AGENDA

IN RE:)
)
140 West 2nd) KETCHUM PLANNING AND ZONING COMMISSION
Design Review) FINDINGS OF FACT, CONCLUSIONS OF LAW, AND
Application File Number: P24-092) DECISION
)
)
Date: March 12, 2024)

PROJECT: 140 West 2nd
APPLICATION TYPE: Design Review
FILE NUMBER: P24-092
ASSOCIATED APPLICATIONS: Pre-Application Design Review P24-070
PROPERTY OWNER: 140 West 2nd Street LLC
REPRESENTATIVE: Michael Doty Associates, Architects
LOCATION: 140 W 2nd Street (Ketchum Townsite: Block 59: Amended Lot 1A)
ZONING: Mixed-Use Subdistrict of the Community Core (CC-2 Zone)
OVERLAY: None

THIRD FLOOR PLAN - EXTERIOR LIGHTING 3
1/8" = 1'-0"

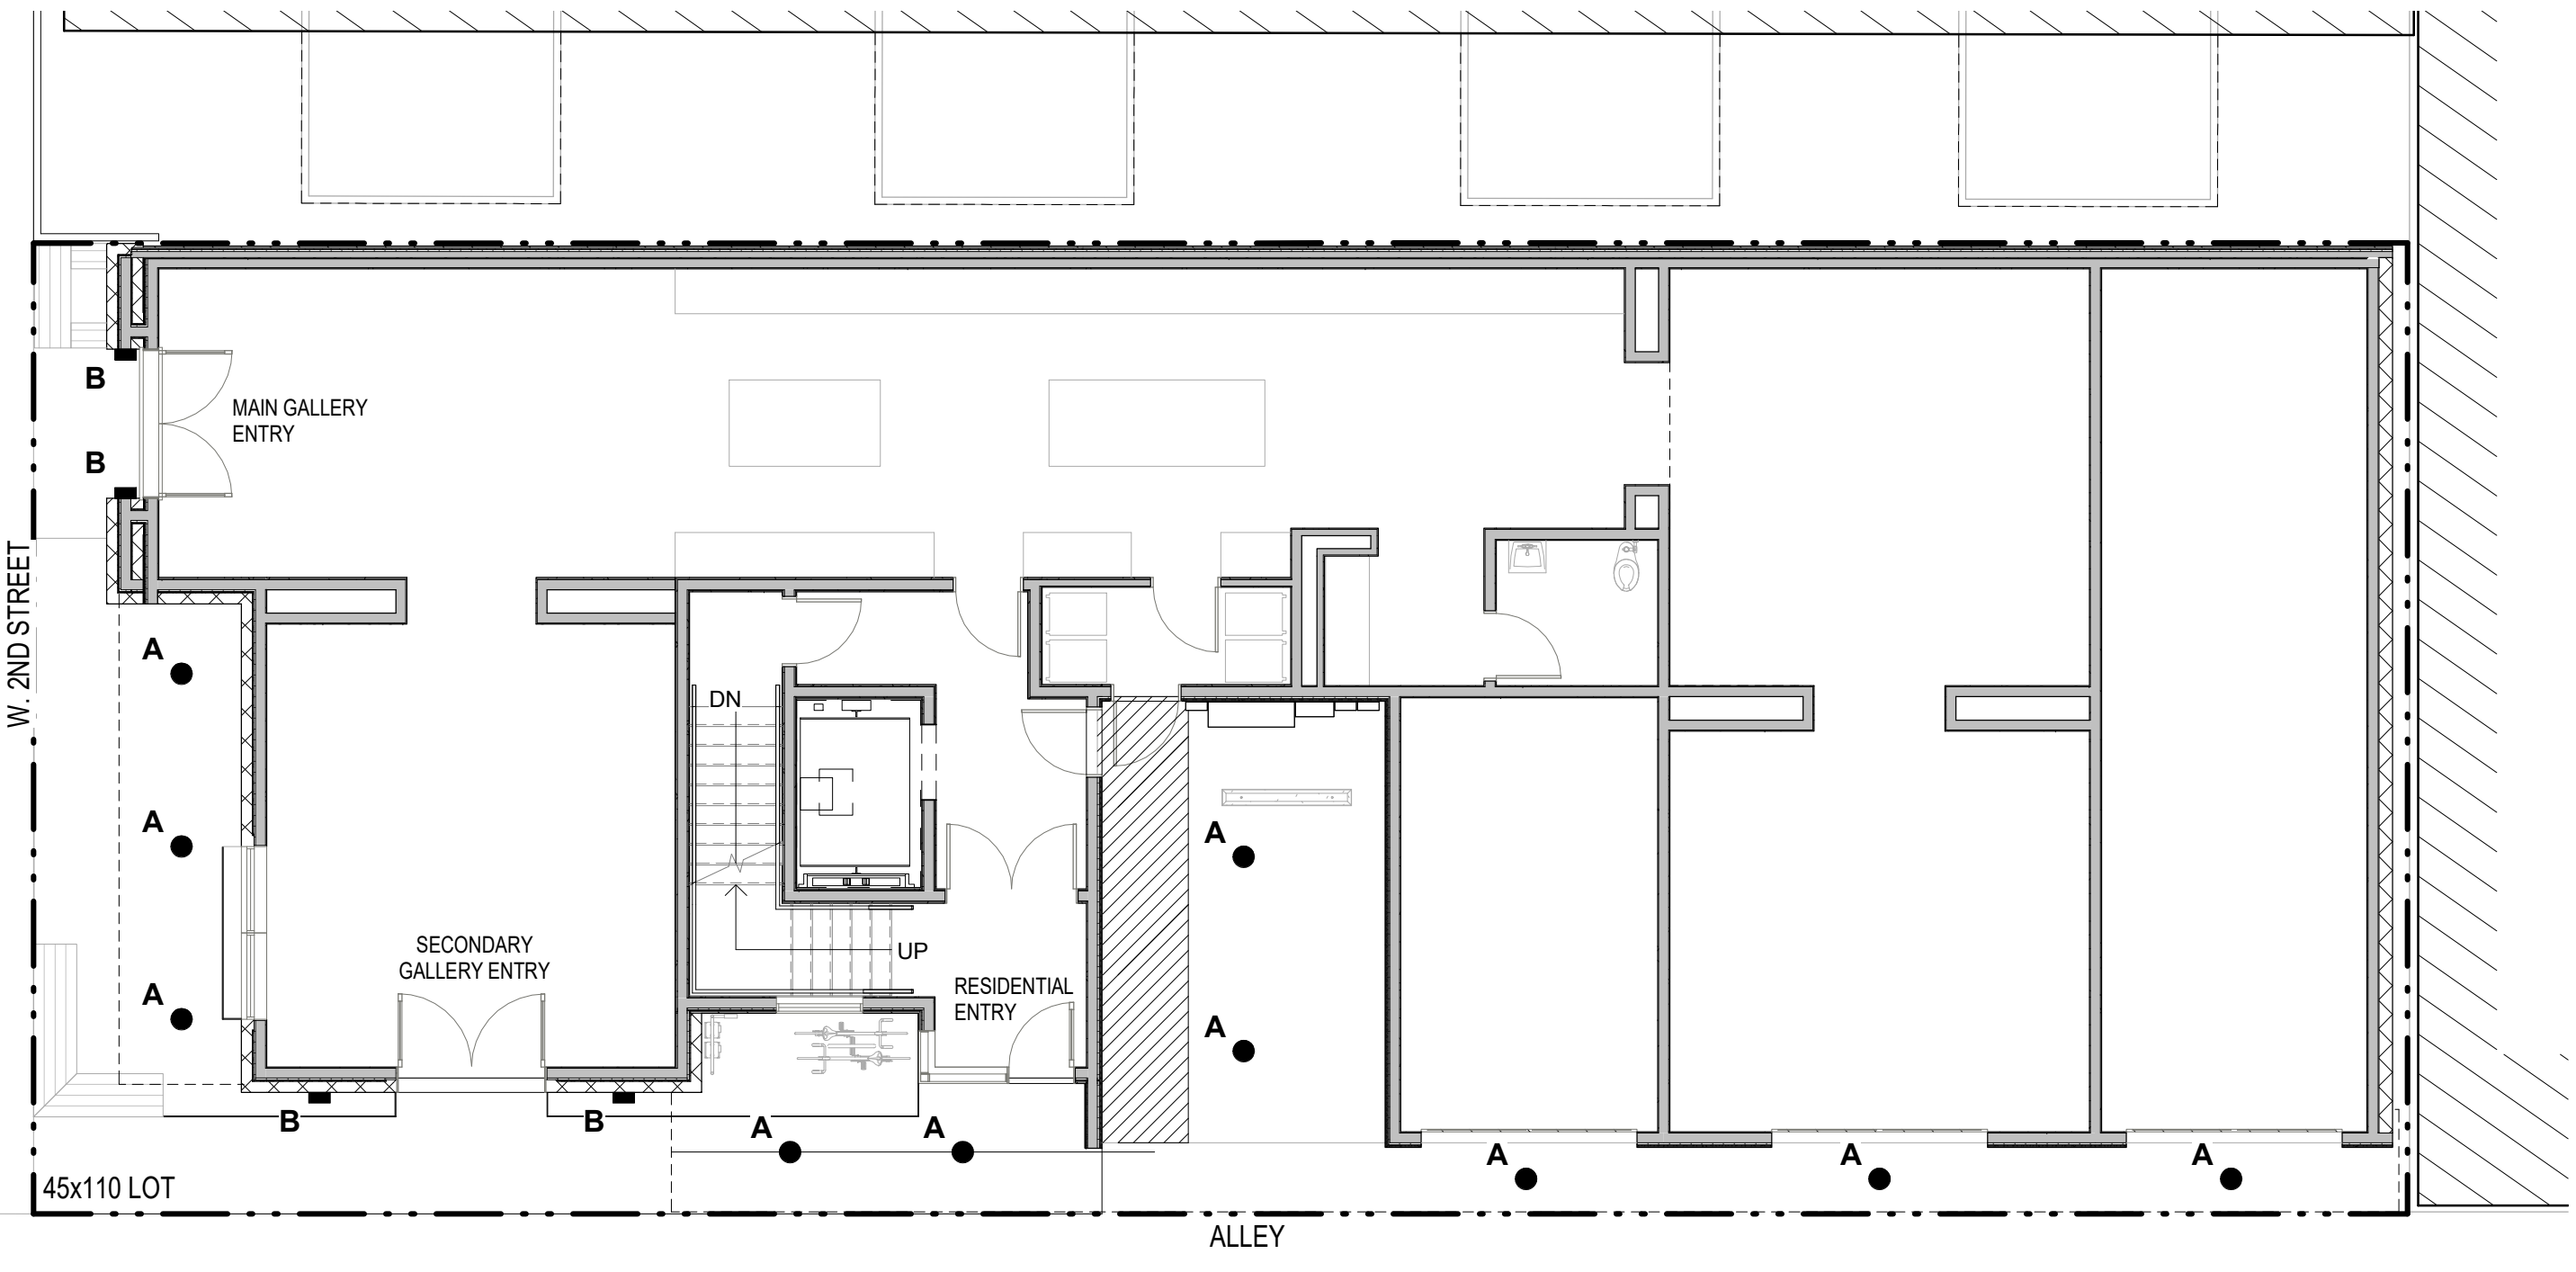
17.132 – Dark Skies	Conformance
<i>Compliance with Section 17.132 – Dark Skies.</i>	YES
<p>Commission Findings: The exterior lighting plan is provided on sheets A-511 & A-512. The exterior lighting fixtures include recessed downlights, path lights, and wall sconces. All exterior lighting is compliant with KMC §17.132.030.H1 as the three fixtures are full cutoff with the light source fully shielded. The light sources used for all three fixtures have a color temperature of 2700 Kelvin, which complies with KMC §17.132.030.A. The photometric study for the on-site exterior lighting shows minimal light trespass along the alley. The light trespass over the west property line along the alley ranges from 0.1 to a maximum of 0.5 footcandles. The light trespass along the alley is consistent with the city’s standards for right-of-way lighting, which requires that the footcandles illuminating the sidewalk shall not exceed an average of 0.2 footcandles and shall not exceed 5 footcandles.</p>

EAST (PROPERTY LINE) ELEVATION

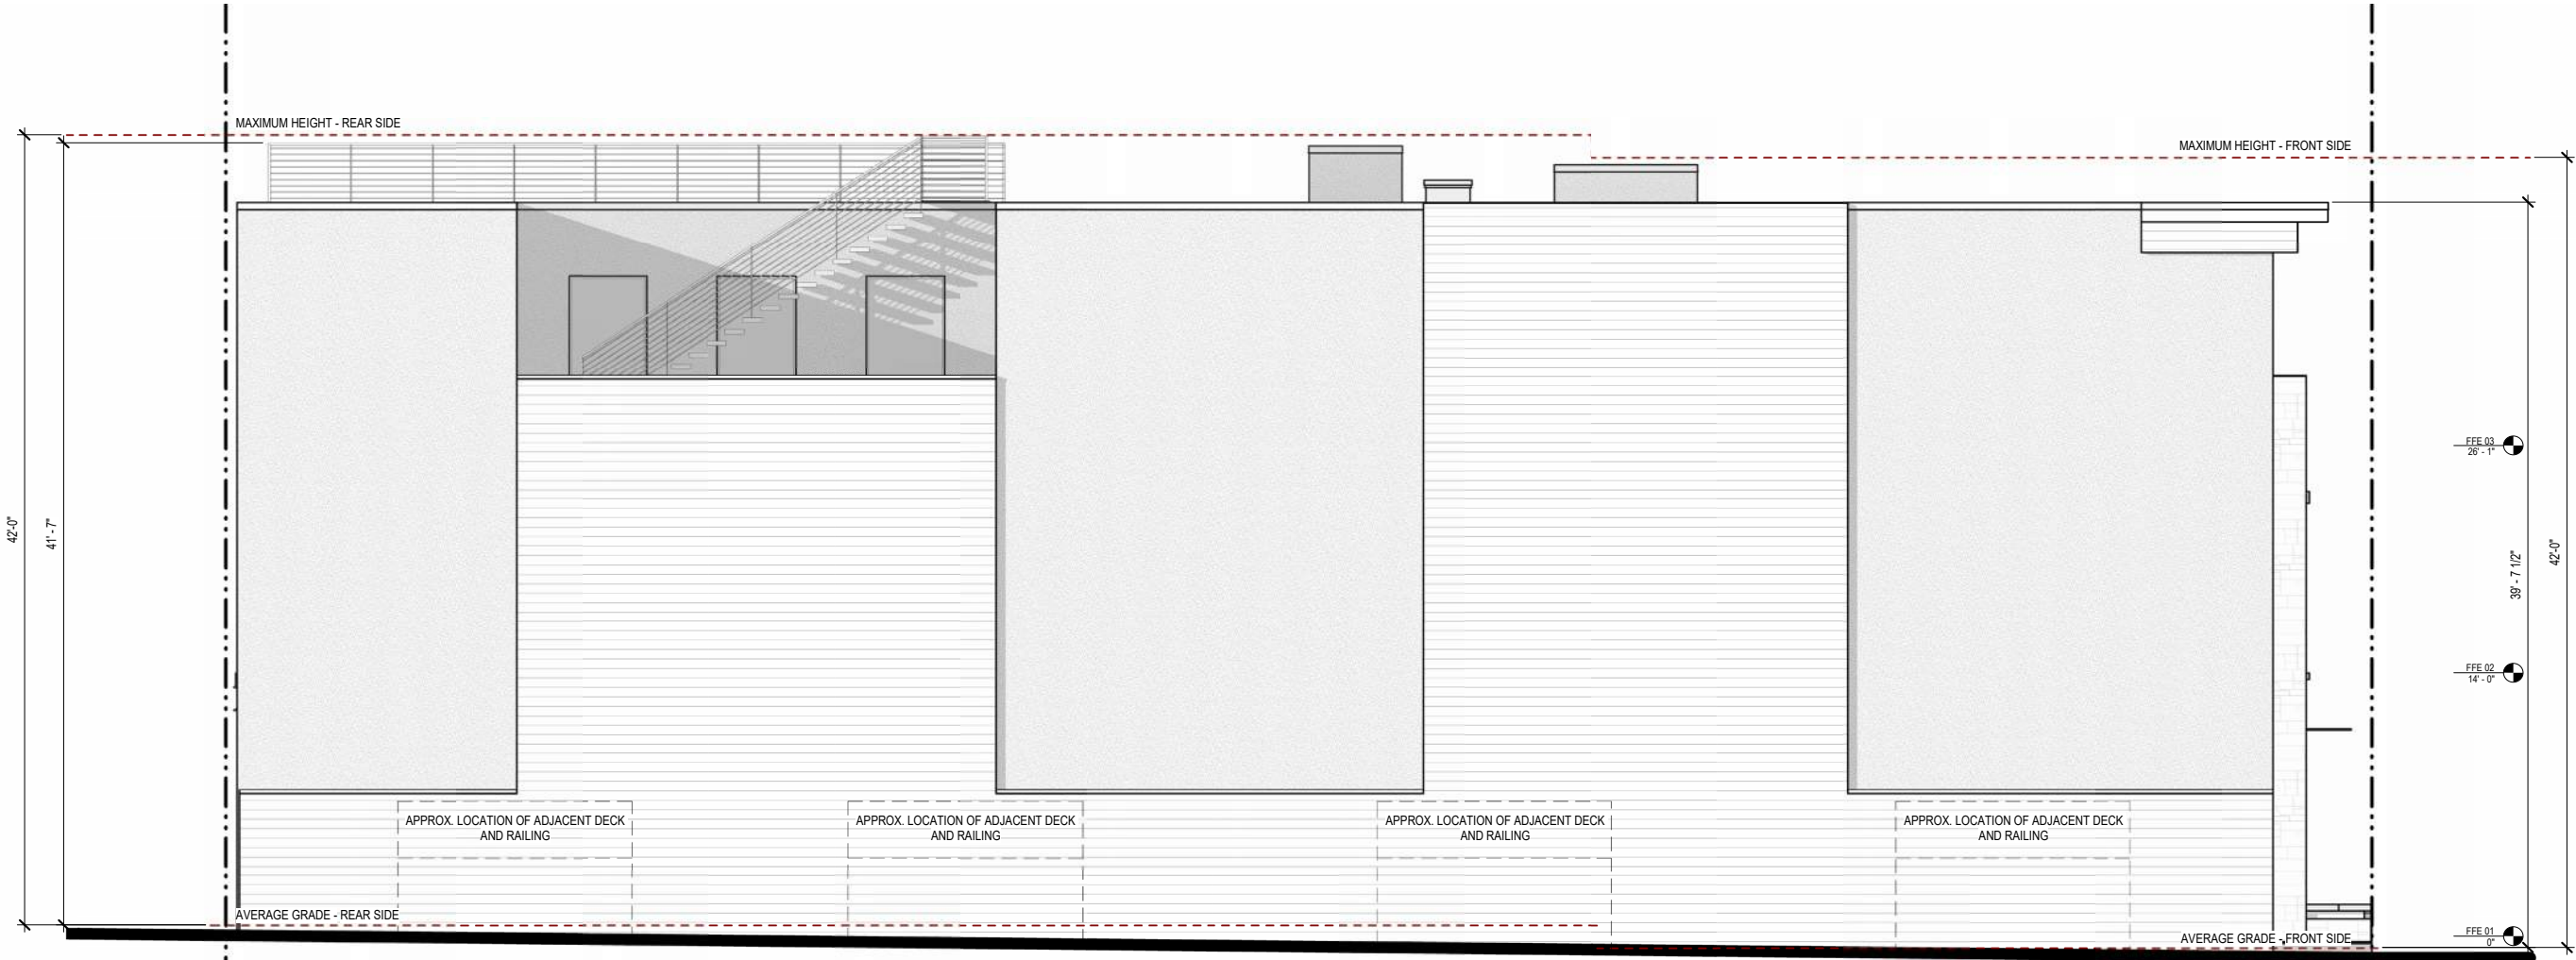
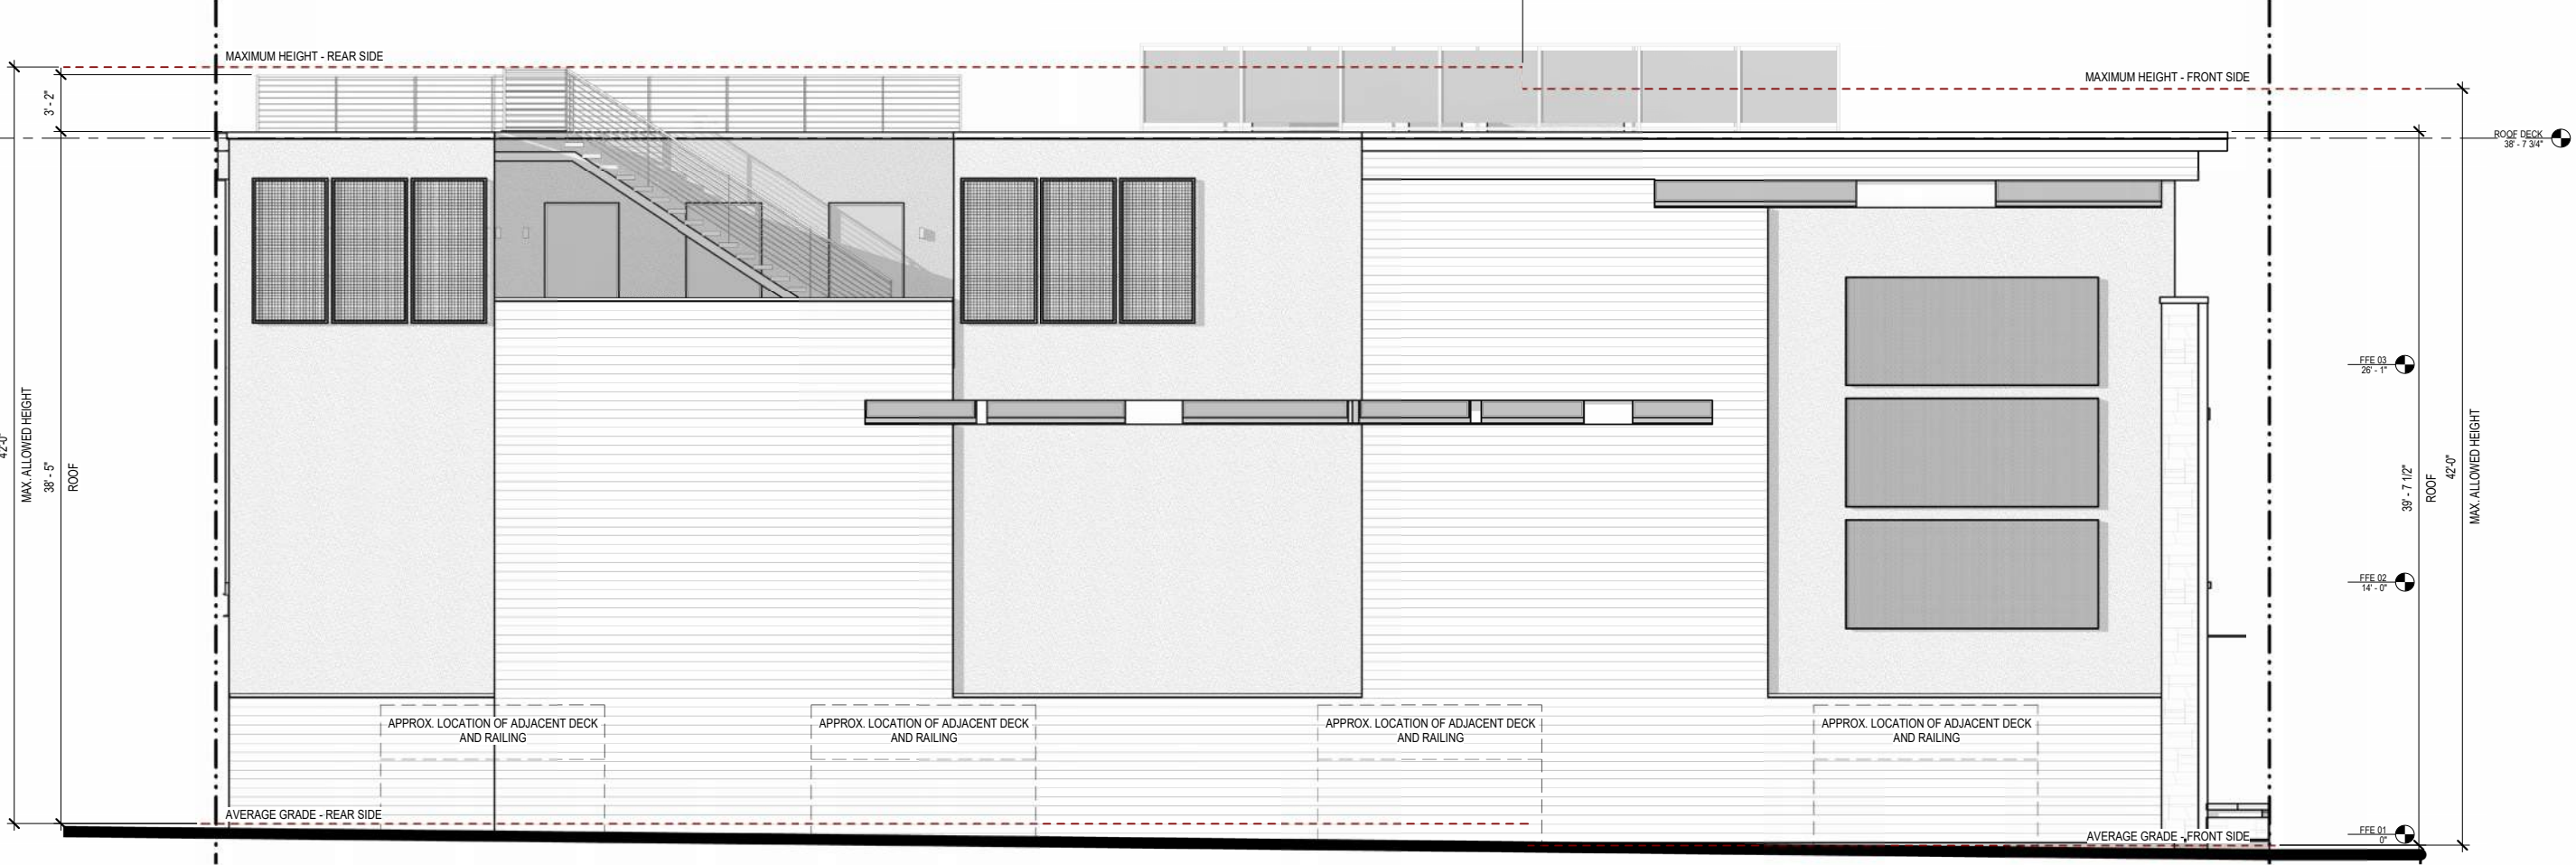
PREVIOUS DESIGN

PROPOSED DESIGN
